MFN 07-439

Docket No. 52-010

**Subject: Response to Portion of NRC Request for Additional Information  
Letter No. 85 - Decay Heat Analysis - RAI Number 6.3-62**

**RAI Number 6.3-62**

Figure 6.3-62-1 (DCD Tier 2, Figure 6.2-8c)

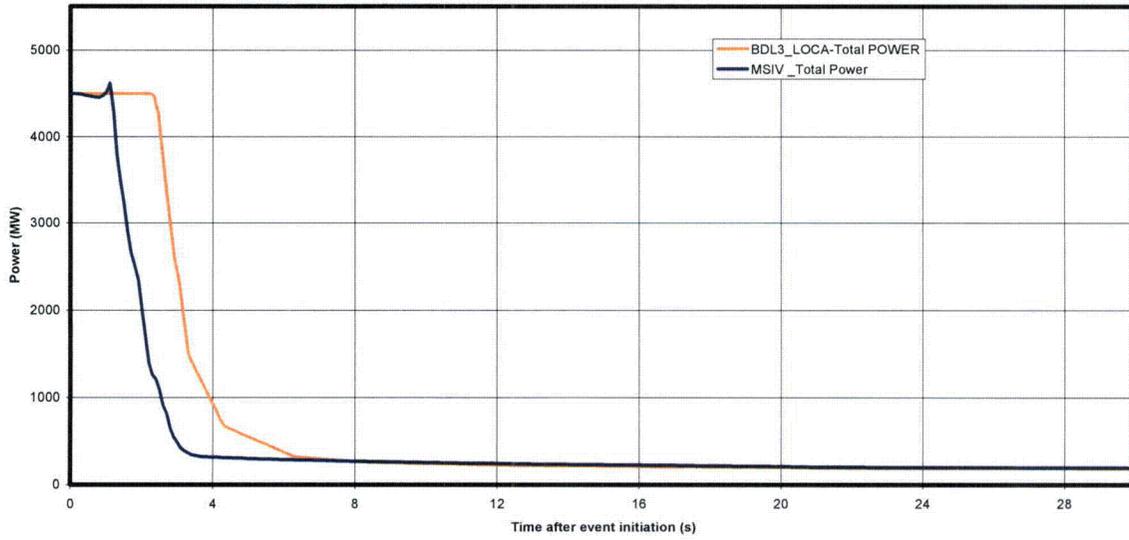
- (B) A justification of the application of the same decay heat curve to both small and large break LOCAs. Particularly, provide an analysis demonstrating that the assumptions used to calculate the fission power during rod insertion and fission power from delayed neutrons are conservative for a full spectrum of LOCAs. If a TRACG analysis is used to demonstrate the conservatism, fully describe the calculation; including the specific decay heat option used, the initiator for the SCRAM signal, the evolution of the core average void fraction, and any assumptions regarding blade insertion time or axial load.*

Figure 6.3-62-1 (DCD Figure 6.2-8c) "Comparison of MSIV Closure Transient and BDL Break LOCA Decay Heat" shows that during both the early high energy gradient and later stages of these events, the decay heat power from the BDL small break LOCA (DCD Tier 2, Revision 3, Subsection 6.2.1.1.3.3) is higher than the one from the MSIV closure transient at EOC (DCD Tier 2, Revision 3, Subsection 15.2.2.7), except for a small time where the MSIV closure transient at EOC decay heat is (about 3%) above the nominal power for about 0.2 seconds (between 1 to 1.2 seconds into the event). Even though the decay heat from the MSIV closure transient at EOC event is slightly higher for a very short time, the contribution from this small peak to total power is shown to be negligible when compared to the time-integrated power for both events (as seen in Figure 6.3-62-2 and Figure 6.3-62-3). Furthermore, the pressure increase due to the MSIV closure transient at EOC and its positive reactivity insertion impact is neutralized by the negative reactivity

from the control rod insertion. The impact on power from the negative void feedback during a BDL small break LOCA is greater than the one caused by the MSIV closure transient at EOC, because the transient event involves more limiting conditions that promote a smaller negative void feedback or none at all. Therefore, based on the behavior shown in the above comparison, it is demonstrated that the same decay heat values are applicable to the LOCA spectrum events identified in DCD Tier 2, Revision 3.

DCD Tier 2, Figure 6.2-8c will be revised consistent with Figure 6.3-62-1 in this response. DCD Tier 2, Subsection 6.2.1.1.3 will be revised to add the text shown in the attached markup.
